Application No: 10/525,359
 Amendment A
 Reply to Office Action dated 06/26/2008

REMARKS

Appendix : Figures 1a, 1b and Figure 2

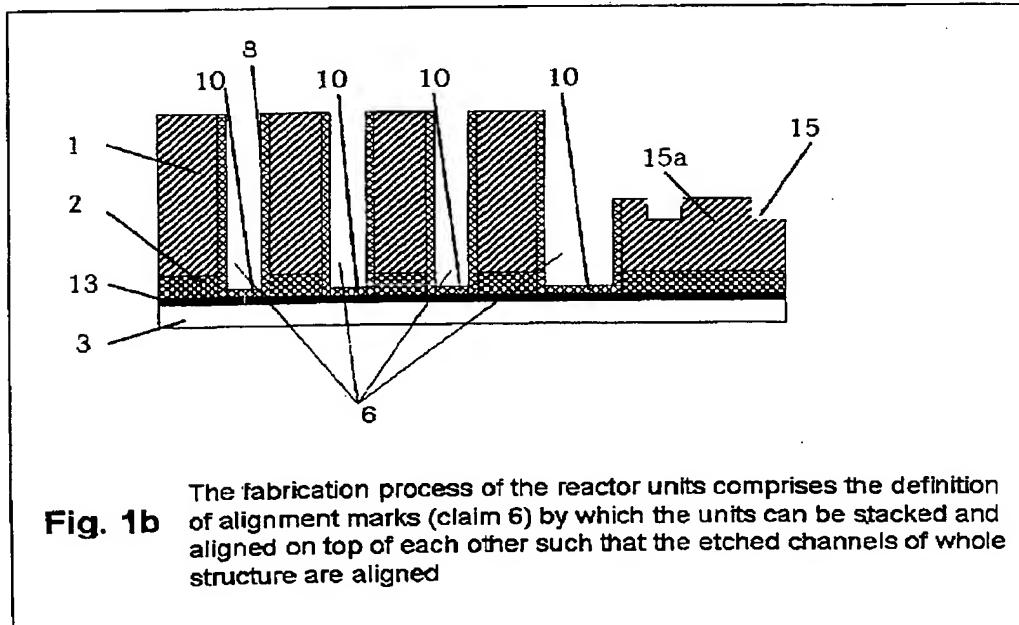
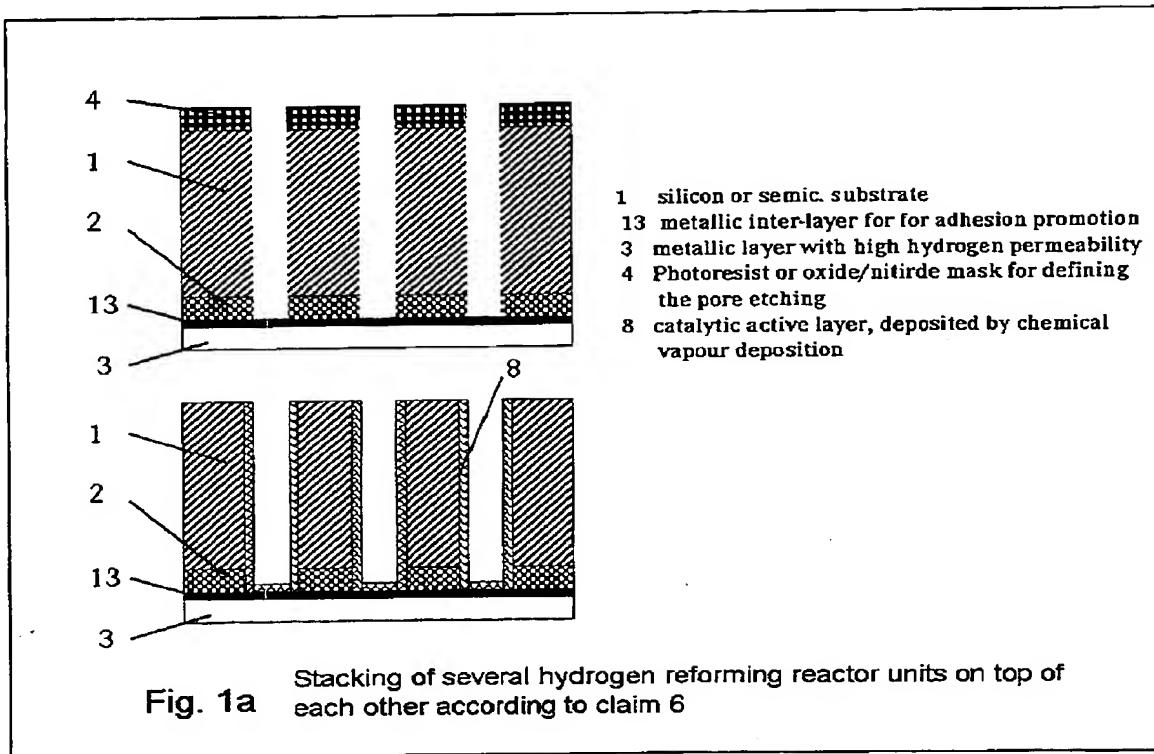
Applicants have drawn two figures to make the 2 variants of combining or stacking of the processed reactor segments clear.

Claim 18 of the present patent comprises the fabrication of the catalyst body in an hydrogen reforming reactor which converts hydrocarbons by e.g. a catalytic oxidation and reforming reaction to hydrogen and carbon monoxide in a catalyst body, typically fabricated from silicon. Its fabrication method is comprised in the claims (claim 25, 33 to 36). First a metallic layer is deposited on one face of the substrate. Then pores, i.e cavities are etched through the whole substrate either by electrochemical etching (deep anodic or photo-anodic etching; claim 26) or by plasma etching (claim 27). The fabrication method of the etched cavities is not an essential part of the invention. The catalyst material is then deposited by vacuum evaporation techniques such as chemical vapour deposition (CVD) on the inner walls of the etched pores. We refer to a so processed structure in this patent as hydrogen reforming reactor segment or unit. By use of the pre-defined alignment marks (claim 28) several of these reactor elements can be

- a) either stacked on top of each other forming a hydrogen reforming reactor (see Fig. 1a +b in Appendix)
